CNATRA NOTICE 1542

Subj: T-45C ADVANCED SYLLABUS ONAV FTI DEVIATION NOTICE (ROAD RECCE
POP-UP TARGET ATTACK)

Encl: (1) 30 Degree Nose High Pop-up Attack Z-Diagram

**30 Degree Nose High
Pop-up Attack Z-Diagram**

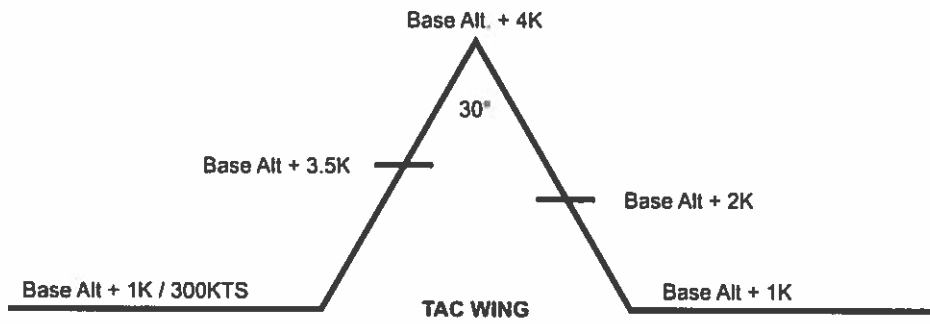
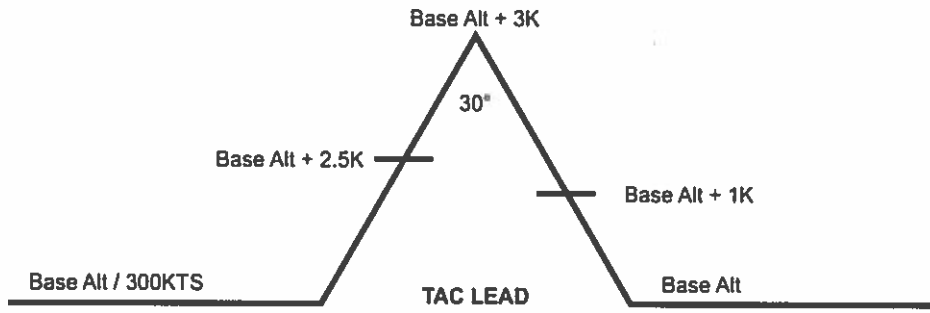
1. Purpose. This notice addresses a possible safety of flight in the Road Reconnaissance syllabus when executing pop-up target attacks. 45 degree nose high pop-up attacks with BRU-38 (bomb rack) results in low airspeed over the top during roll in execution. This notice places restrictions on 45 degree nose high pop-up attacks, and authorizes 30 degree nose high pop-up attacks in accordance with enclosure (1).

2. Action. 30 degree nose high pop-up attacks are authorized in any of three Strike configurations, slick, with pylons only, or with pylons/BRU-38 bomb rack combination. 45 degree nose high pop-up attacks are authorized in the slick or pylon only configurations. No 45 degree nose high pop-up attacks with BRU-38s are authorized.
